No. 93-5

A. REQUIRED FUEL PUMP PUSH ROD REPLACEMENT

MCM 5.7L Bravo Stern Drive Engine Only
Serial Number: 0F009141-0F014479

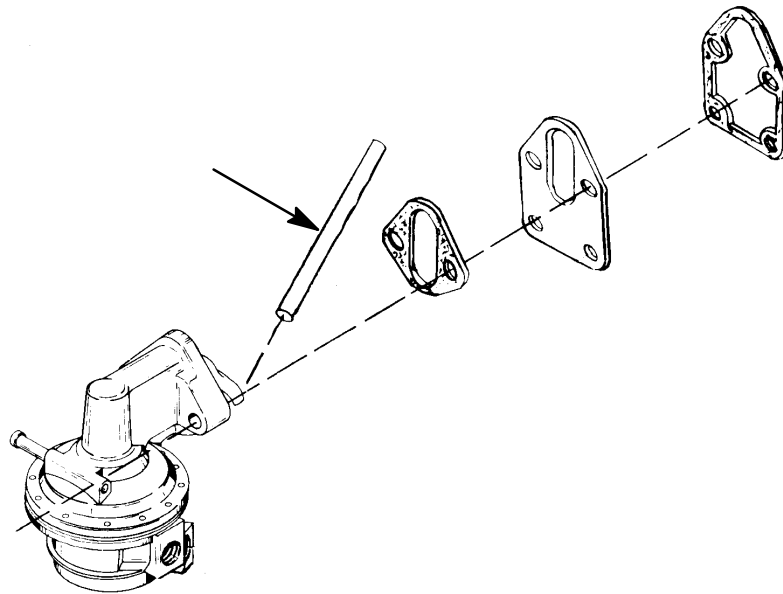
This engine has a steel camshaft in it and it takes a different fuel pump push rod than engines with the cast camshaft. During assembly, the wrong push rod was installed. This wrong push rod can cause premature camshaft fuel pump lobe and/or push rod wear.

The two push rods look alike. Please order the correct push rod by part number and install it in the engine.

- (1) 821150 Push Rod
- (1) 27-34213 Fuel Pump Gasket
- (1) 27-34898 Mounting Plate Gasket
